Subject: RE: Information from IDEM OAQ Permits regarding Tradebe Treatment and Recycling LLC

Attachments: Tradebe_Air Emissions_Mass Balance_5-4-17.docx

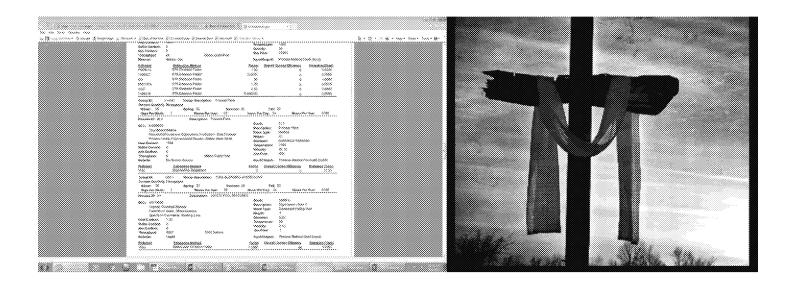
From: Valentino, Michael [mailto:Valentino.Michael@epa.gov] Sent: Wednesday, May 03, 2017 12:56 PM To: Bell. Nathan <NBELL@idem.IN.gov> Cc: Cunningham, Michael <cunningham.michael@epa.gov>; Lee, Jae <lee.jae@epa.gov> Subject: RE: Information from IDEM OAQ Permits regarding Tradebe Treatment and Recycling LLC **** This is an EXTERNAL email. Exercise caution. DO NOT open attachments or click links from unknown senders or unexpected email. **** Nathan, This is extremely helpful. Thank you for providing such detailed and helpful information in such a short time! I have a lot to pour through but did want to ask if FL1 exceeded its 23.4 TPY limit as the screen capture shows 27.21 TPY calculated from the flare for 2015 [Would this be a violation? **PBI / Ex. 4** So I understand correctly. SDS II has a total emission rate of 95.6 TPY for VOCs which includes VRU II (which vents to the flare, FL1), but the 23.4 TPY VOC for FL1 only applies to the (controlled) VOCs from VRU I (serving SDS I), correct? VRU II emissions are grouped into the overall 95.6 TPY figure? To answer your question, yes I did use the IGL to derive flare vent gas density (= PM/RT), and also relied on the two attached documents provided to me by Region 5 Air Division. **PBI / Ex. 4** PBI / Ex. 4 Here is the vent gas summary table I compiled. I did a weighted average calculation of monthly volumetric flowrates and monthly VOC concentrations from the attached Excel spreadsheet to derive HC concentration (ppmw) for each of the years 2013-2015 (again, this is in the first table I included below). PBI / Ex. 4

I calculated FL1 stack emissions by: uncontrolled VOC to flare (lb/hr) * (1 Ton/2000 lb) * (hours of operation/for a given year) * (1-0.98) at 98% DRE. For 99% DRE, the last term is (1-0.99), which halves the emission rate (controlled) as that for 98% DRE.
